11 August 2025

Arc Infrastructure's statement of the depreciated optimised replacement cost, depreciation schedule and supporting material – Invitation for public submission

Co-operative Bulk Handling Limited (**CBH**) is pleased to provide feedback to the Economic Regulation Authority (**ERA**) in relation to Arc Infrastructure Pty Ltd's (**Arc**):

Figure 1: Comparison of escalated 2014 GRV and 2025 ORC / DORC (\$m)⁷

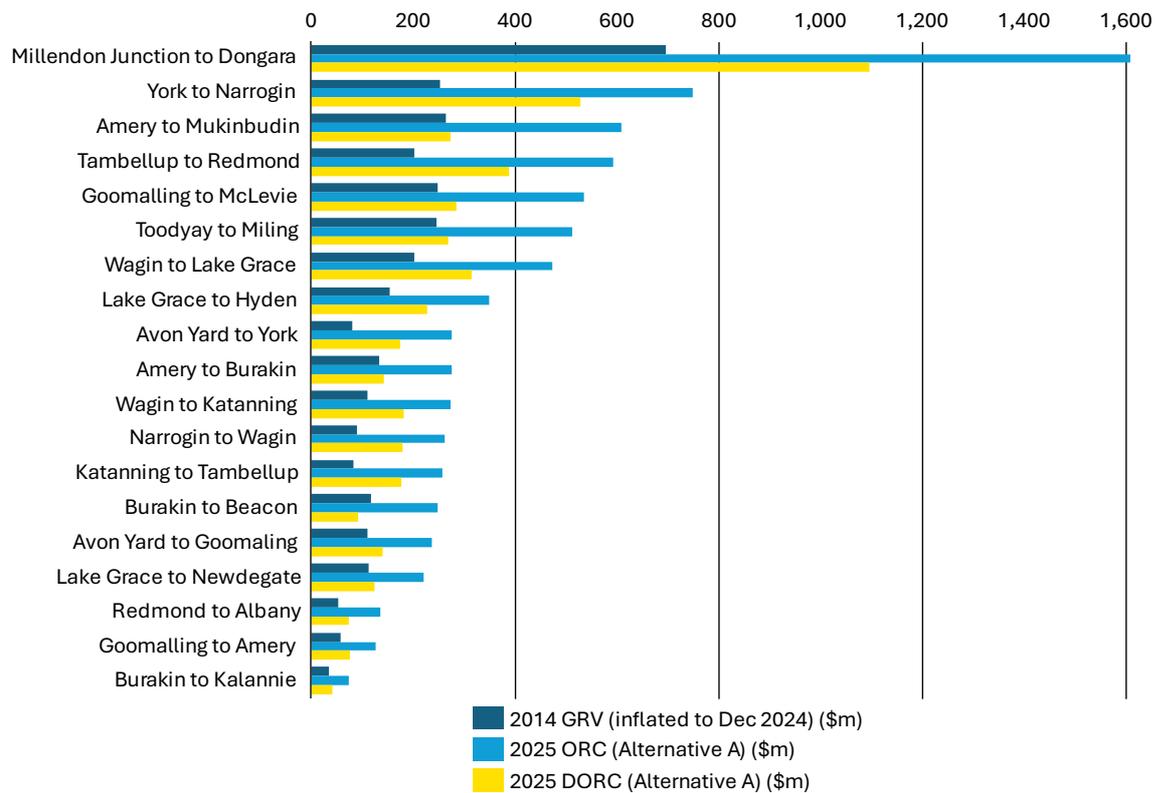
9. This is further supported by Figure 1, which compares escalated GRV values from the ERA's Brookfield Rail (now Arc) Determination of Costs Relevant to CBH's Access Proposal dated 10 December 2013 (**ERA's 2014 determination**) to Arc's proposed optimised replacement cost (**ORC**), (which is equivalent to GRV) and DORC values for selected lines.⁵ Unredacted GRV values were escalated to 2024 terms using the Western Australian Road and Bridge Construction index, which results in 2014 rates increasing by a factor of 1.32.⁶ The Western Australian Road and Bridge Construction index was selected as it reflects cost escalation associated with the construction of similar infrastructure to that identified in Arc's DORC Report.

10. This comparison illustrates that Arc's DORC values, which *include* depreciation, are on average 47% higher than GRV values, which *exclude* depreciation.

Figure 2: Rawlinson's 2025 regional indices

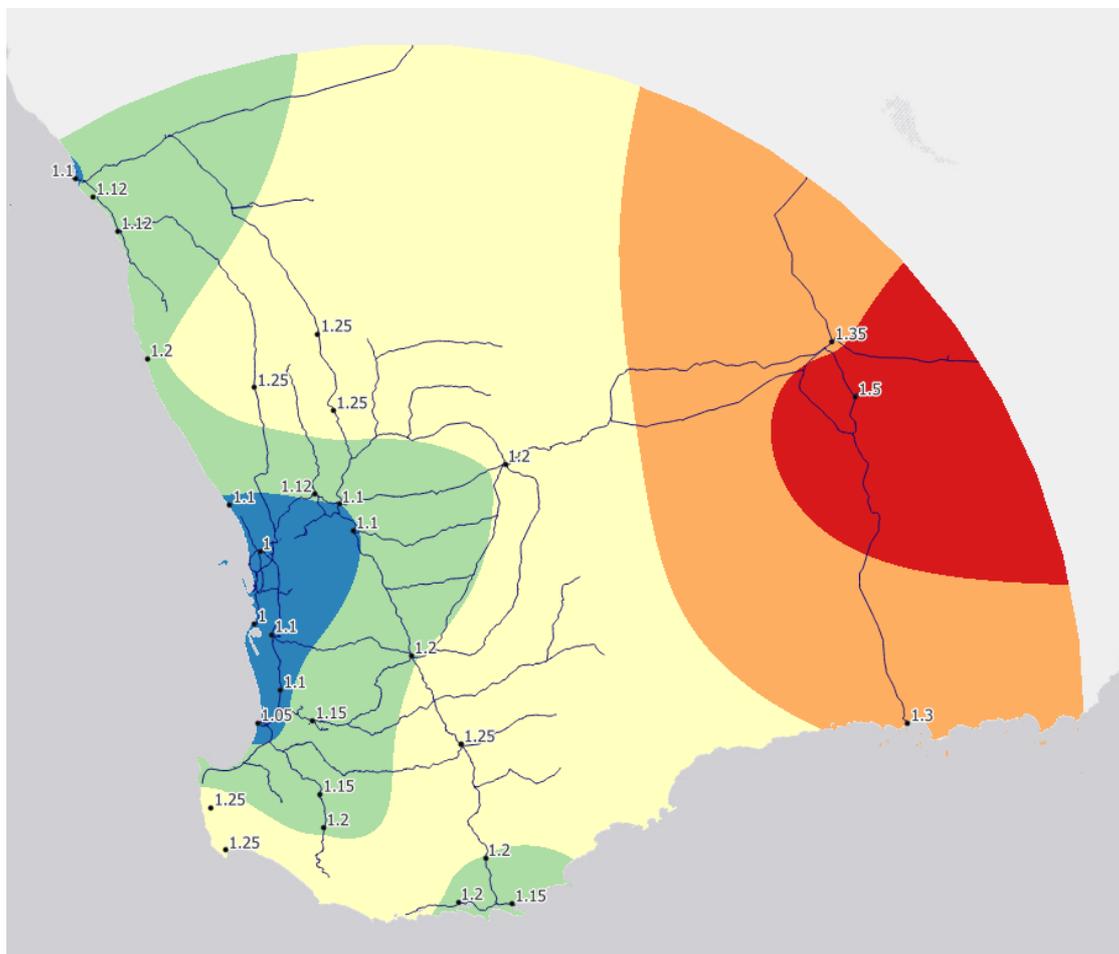
46. In this section, Arc proposes escalation factors to be applied to direct costs to account for increased costs associated with regional construction. The proposed factors are based on GHD's experience and are displayed in map form in Figure 4-2 of Arc's DORC Report.
47. In both the ERA 2014 Determination and the ARTC DORC Report, regional indices used to calculate the cost of constructing assets in different geographic areas were taken from an independent information source - Rawlinson's Australian Construction Handbook.
48. CBH has prepared a map overlaying Rawlinson's 2025 regional indices with the freight rail network below.¹⁶ In most instances, the Rawlinson's regional factors are lower than those proposed by Arc, except for Arc's proposed factor in "Central Zone".

- (a) Arc should adopt Rawlinson's 2025 regional indices in place of the indices proposed by GHD.
- (b) Arc should provide weighted average location factors at a Code route level.

Figure 3: Comparison of total bridges and culverts costs (\$m)

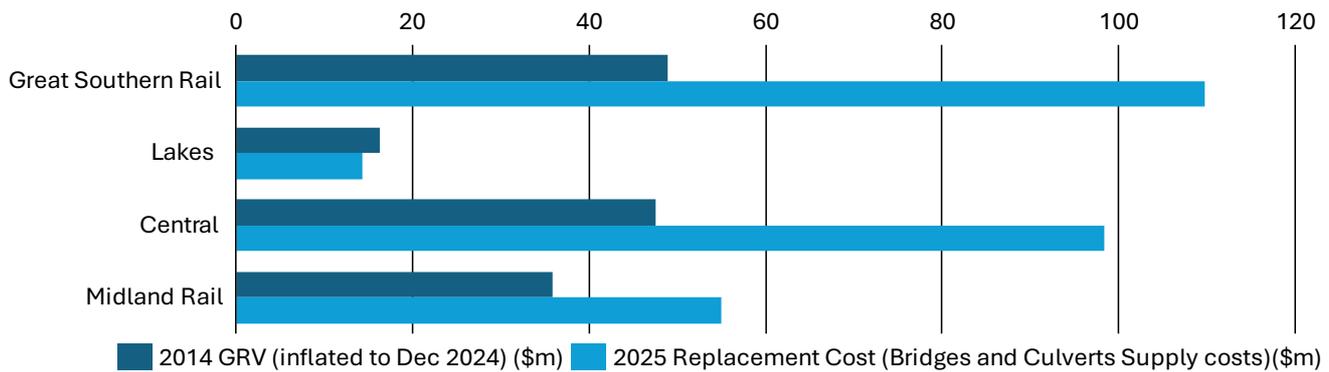
105. In this section, Arc have specified five different MEA bridge types, which all have a 24-tonne load rating. Arc have provided the number of bridges, total deck area and \$/m² on a Network Group basis.
106. Figure 3 below compares total bridge and culvert costs escalated from the ERA 2014 Determination to Arc's proposed replacement cost for bridges and culverts for a subset of Network Groups where information was available. 2025 bridge and culvert costs were amalgamated to align with the 2014 Determination data structure. This demonstrates the 2025 bridge and culvert replacement costs are on average 1.9 times escalated 2014 values.²³

Figure 5: Comparison of Tracklaying costs (inclusive of contractor indirect costs) (\$m)

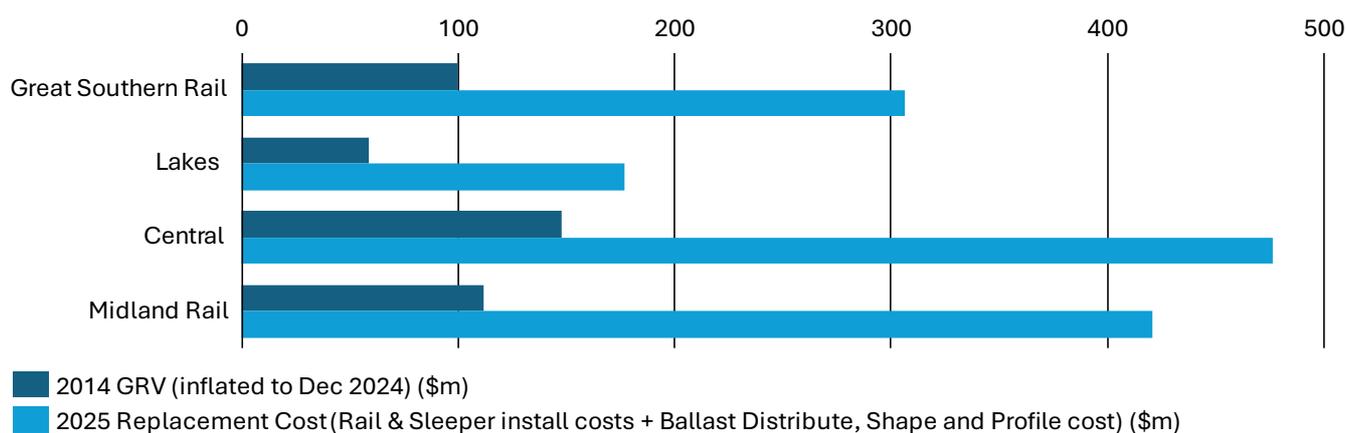
126. Arc’s rail install rate of \$125,000 per km (excluding contractor indirect costs) cannot be directly compared to the ERA 2014 Determination rate as in this Determination, tracklaying was combined with rail, sleeper and ballast installation rates.
127. A comparison of amalgamated Arc rail and sleeper installation costs and ballast distribute, shape and profile costs with the escalated tracklaying costs from the 2014 Determination is presented in Figure 5. This illustrates that the combined ‘tracklaying’ rates proposed by Arc are on average 3.4 times escalated 2014 rates.³²

Figure 6: Comparison of total sleeper supply costs (inclusive of contractor indirect costs) (\$m)

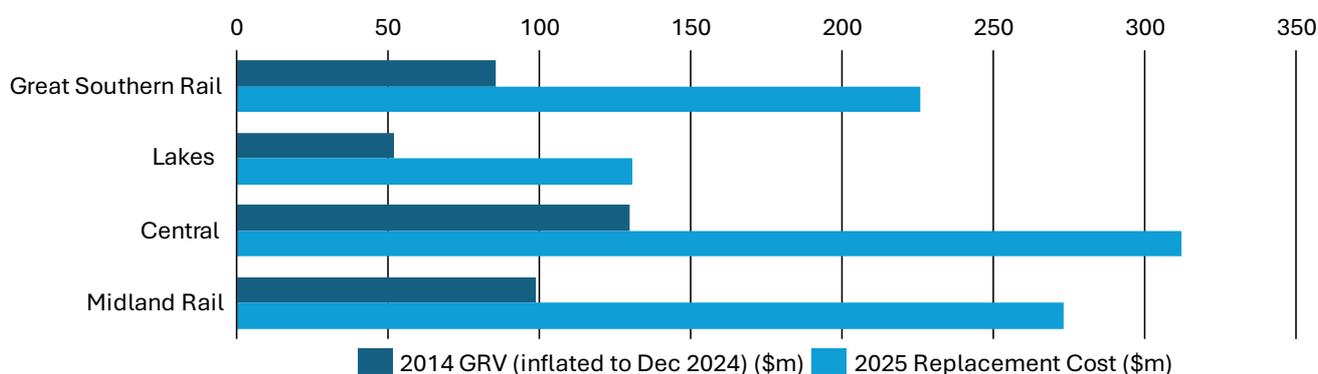
- 132. Arc have proposed use of concrete sleepers across the entire network at a frequency that replicates current sleeper spacing.
- 133. Arc did not differentiate sleepers by gauge, even though narrow and standard / dual gauge sleepers differ in terms of length, weight and cost.
- 134. Figure 6 below compares escalated total sleeper supply costs from the ERA 2014 Determination to Arc’s proposed sleeper supply costs for a subset of Network Groups where information was available. This demonstrates the 2025 replacement sleeper costs are on average 2.7 times escalated 2014 values.³⁶

Figure 7: Comparison of total ballast supply and cart cost (inclusive of contractor indirect costs) (\$m)

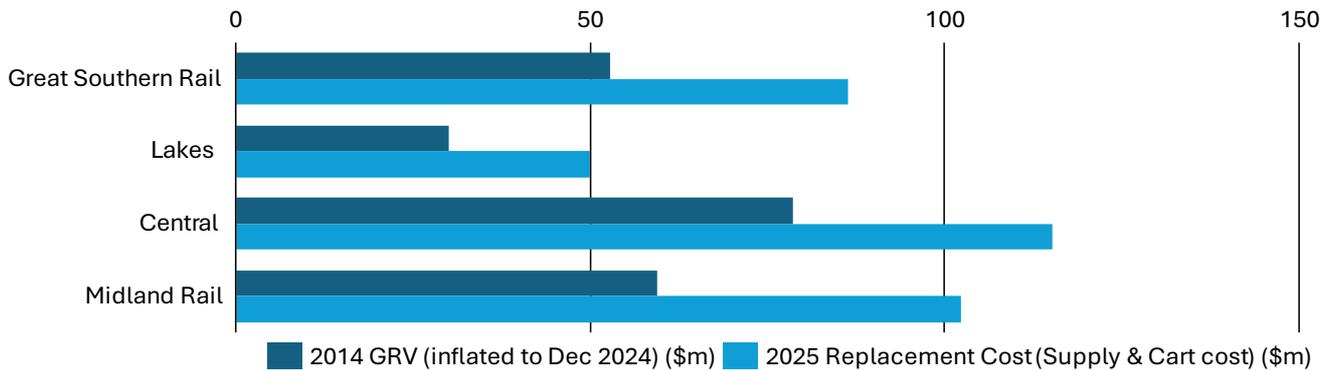
146. CBH submits these back solved unit rates appear reasonable.
147. Figure 7 below compares total escalated ballast supply costs from the ERA 2014 Determination to Arc's proposed ballast supply and cart costs for a subset of Network Groups where information was available.⁴³ The 2025 total ballast supply and cart costs are on average 1.7 times escalated 2014 values. This demonstrates the likely impact of gold-plated specification assumptions and the application of significant margins.

Figure 8: Comparison of total signalling and communications costs (inclusive of contractor indirect costs) (\$m)

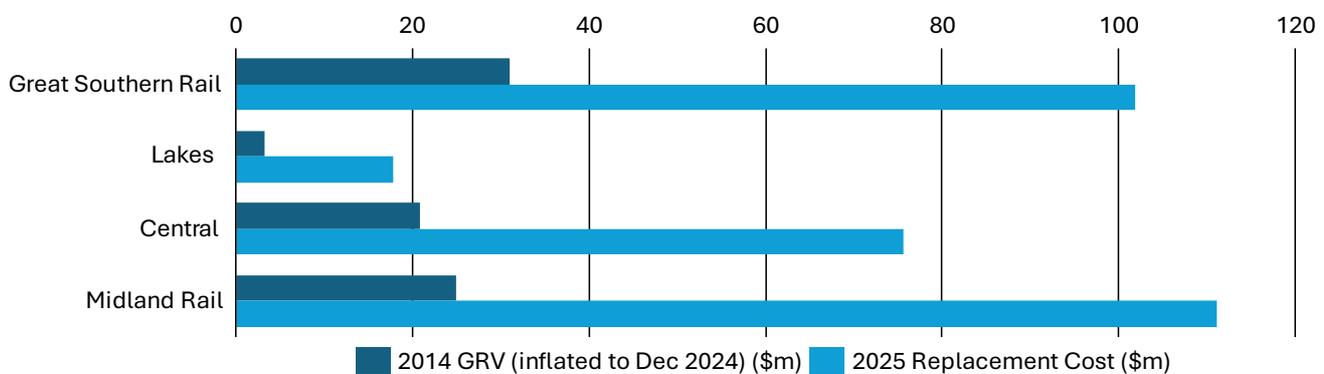
156. CBH submits that the margins applied to signalling and communications infrastructure are excessive and unreasonably inflate replacement costs.
157. The extent of this over-inflation can be seen in Figure 8 below which compares total signalling and communications costs from the ERA 2014 Determination to Arc's proposed signalling and communications costs for a subset of Network Groups where information was available.⁴⁷ This demonstrates Arc's 2025 signalling and communications costs are on average 4 times escalated 2014 values.

Figure 9: Telstra 5G and 4G coverage map⁵²

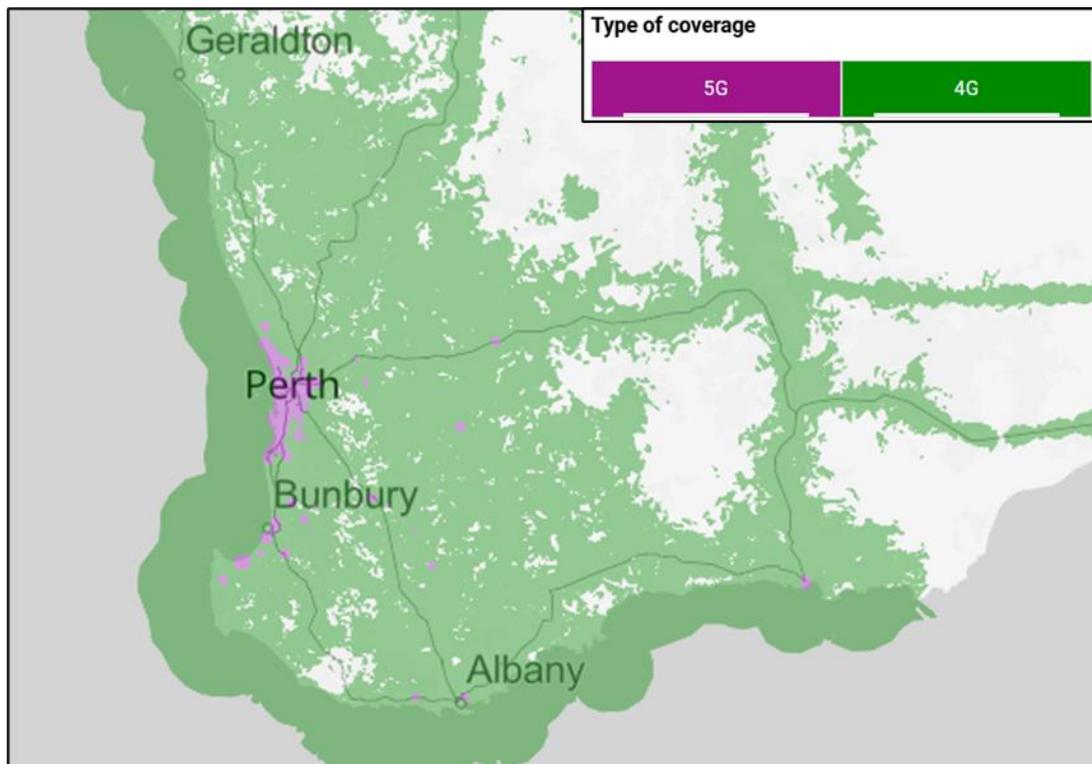
244. Similarly, the costings for radio towers fail to account for existing infrastructure. There is precedent in the Australian rail industry for utilising existing Telstra towers to support railway radio infrastructure, removing the need to construct dedicated rail radio towers. As illustrated in Figure 9, there is a minimum of 4G coverage across the entire CTC-controlled network (which would be costed as an RBTC MEA), except for a small section of approximately 10 km near Northern Gulley, east of Geraldton.

245. As 4G has a shorter transmission radius than the 15km proposed by Arc (inferred from Table 5-7), most of the network's radio tower requirements could be met by leveraging existing third-party structures. Therefore, no radio towers should be included in the DORC; only the telecommunications equipment installed on existing Telstra towers to enable RBTC should be accounted for.

Figure 10: Comparison of signalling and communications rates (\$m/km)

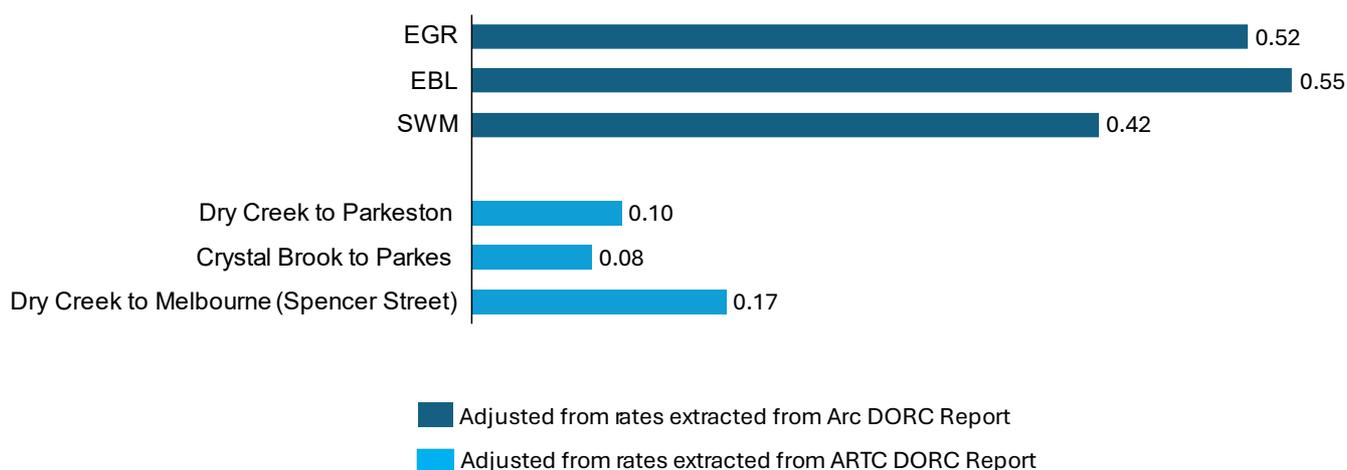
249. CBH is concerned that similar cost increases may be reflected across other areas.
250. This is further supported by a comparison of signalling and communications costs from Arc’s DORC Report and the ARTC DORC Report (which included a comparable ETCS 2 compliant communications-based train control system) as shown in Figure 10. To enable a like-for-like comparison, CBH removed all location factors and specialist/principal contractor indirect costs from both sets of rates and escalated the ARTC figures for comparable line sections.⁵⁶ A comparison of unit rates for longer sections through regional areas—featuring similar terrain to some of Arc’s proposed non-metropolitan routes—illustrates a significant discrepancy in per kilometre costs.

251. CBH submits that Arc should adopt a fibre optic supply, testing, commissioning and installation rate of \$99 per metre.
252. Furthermore, the ERA should validate all other proposed signalling and communications quantities and rates as they appear high compared to other benchmarks.

Figure 11: Comparison of funding costs (\$m)

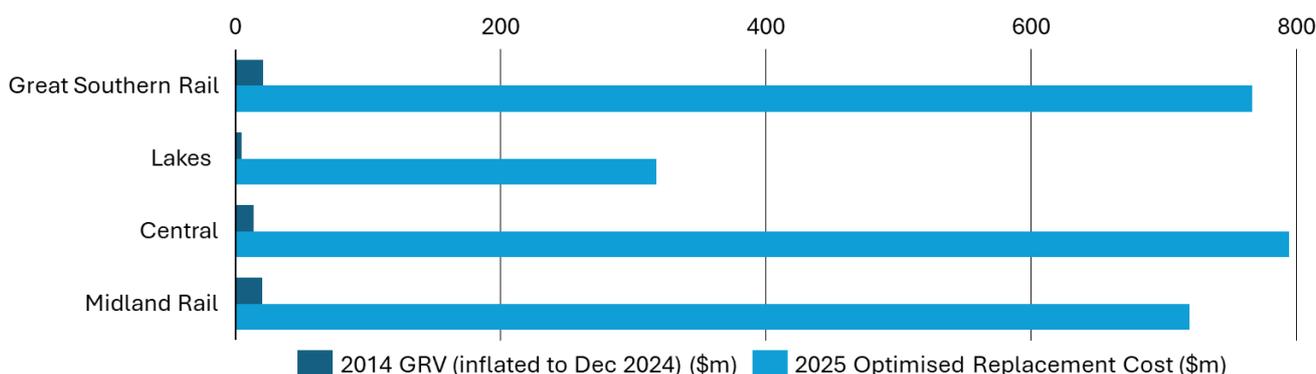
- 303. In summary, the funding costs included in Arc’s DORC Report are significantly higher than those seen in any other comparable DORC valuations and are inconsistent with past regulatory precedent in WA.
- 304. CBH submits that Arc should adopt the approach and assumptions set out in the ERA 2014 determination.

- (b) The time and costs associated with the construction of access roads and pre-construction planning, design and approvals should be removed.
- (c) ERA should reject Arc’s proposed project development schedule and direct Arc to adopt the same approach that was set out in its 2014 Determination.
